ORDER OF CONDITIONAL
APPROVAL OF FINAL PLAT

ORDER OF CONDITIONAL APPROVAL OF FINAL PLAT
FOR (CENTERVILLE SUBDIVISION NO. 3 – FILE # FP-2025-0008)

COMMUNITY DEVELOPMENT DEPARTMENT REPORT

SUBJECT: FP-2025-0008
Centerville Subdivision No. 3 - FP

E. Landscape Plan (date: 4/3/2025)

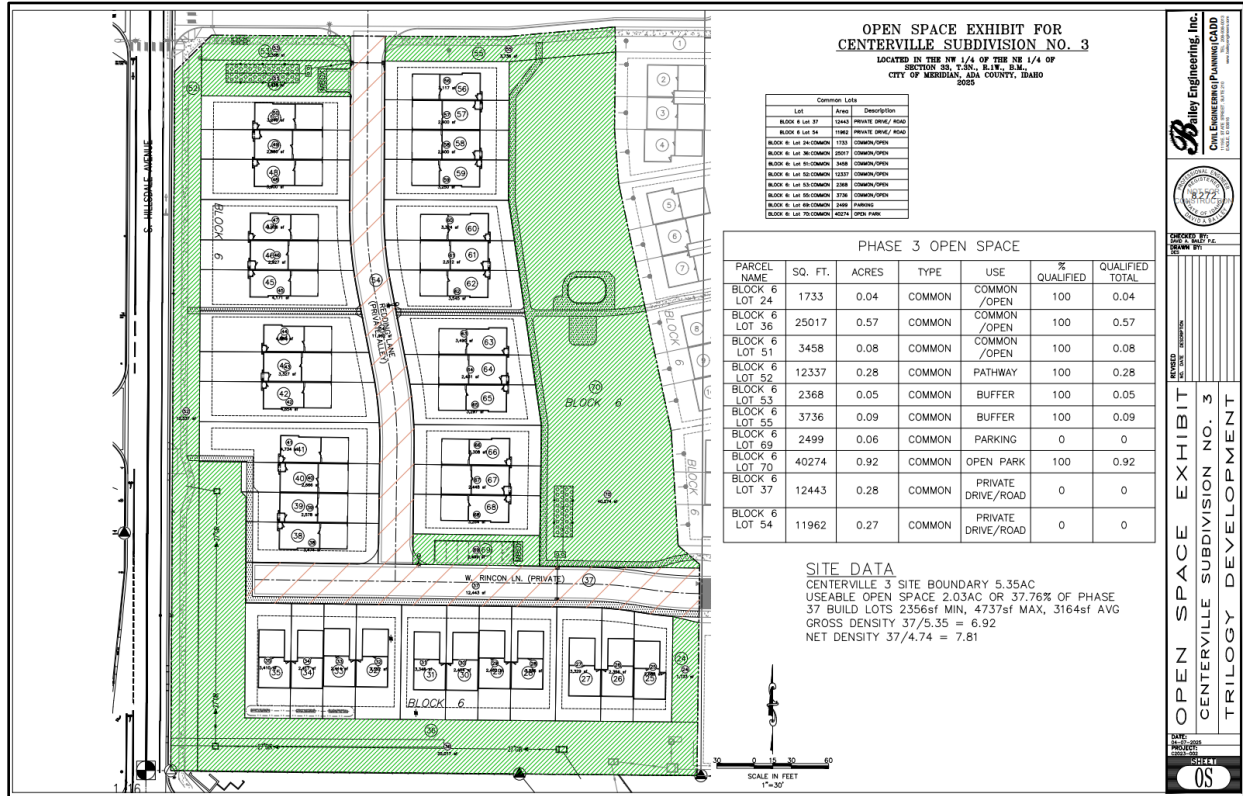
- f. Replace the street named Redding Lane with S. Sapulpa Lane per Ada County's Street Name Review approval.
4. The landscape plan prepared by Jensenbelts Associates, dated April 3, 2025, shall be revised as follows:

- a. Graphically depict the fence around the common area and provide fence details on the landscape plan.
 - b. Graphically depict any fencing that will be provided as part of the subdivision and provide the fence details on the landscape plan.

- c. Show the proposed landscape for the Cunningham easement. Staff would recommend providing lawn in that area.
5. Future development shall be consistent with the minimum dimensional standards listed in UDC Table 11-2A-7 for the R-15 zoning district.
